# SERVICE LETTER

Service Letter No. L248 January 14, 2011

SUBJECT: O-235 Crankcase Design Upgrade

Figure 1. Twin Pressurized Oil Galleys, Tappet Boss Diameter Enlarged

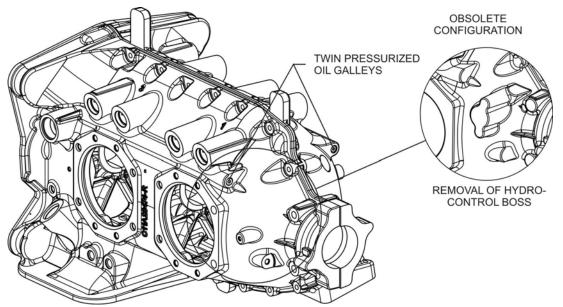
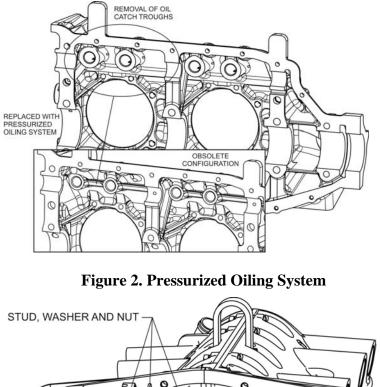
Lycoming Engines has released a new crankcase design for the O-235 engines. The new crankcase uses twin pressurized main oil galleys (Figure 1) to supply oil to both banks of tappets and all camshaft journals. The new design removed the hydro-control boss and oil catch troughs (Figure 2). In the existing O-235 crankcase, oil drains by gravity into the catch troughs through tappet bores to lubricate tappets and the camshaft. Plugs also are installed on the new crankcase. Refer to Figures 3 and 4.

Figure 4. Location of Identification Plate on Old O-235 Crankcase

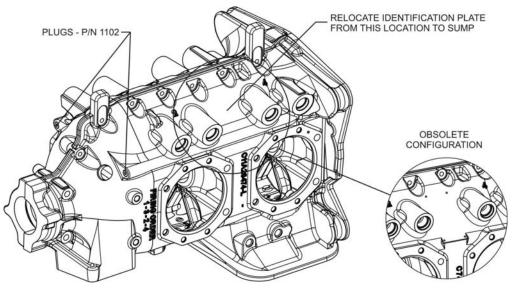
©2011 Avco Corporation. All Rights Reserved. Lycoming Engines is a division of Avco Corporation. When replacing the old O-235 crankcase with the new O-235 crankcase, the engine identification plate must be removed from the old crankcase (Figure 4) and installed on the oil sump of the new O-235 crankcase where shown in Figure 5. The engine identification plate can be removed one of two ways:

Figure 5. Relocate Identification Plate to Sump

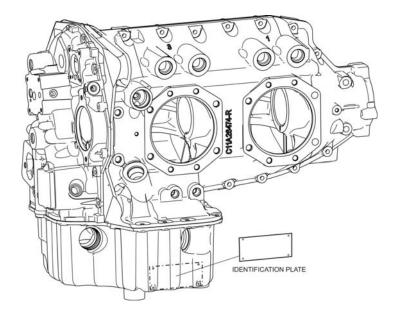
The oil sump already has four blind pre-drilled holes for installing the engine identification plate with the four new drive studs P/N STD-1901. Install the engine identification plate on the oil sump of the new crankcase aligned with the four holes in the location shown in Figure 5. To securely attach the engine identification plate to the oil sump, install the four drive studs, one in each of the four predrilled holes, using a drift and a hammer.
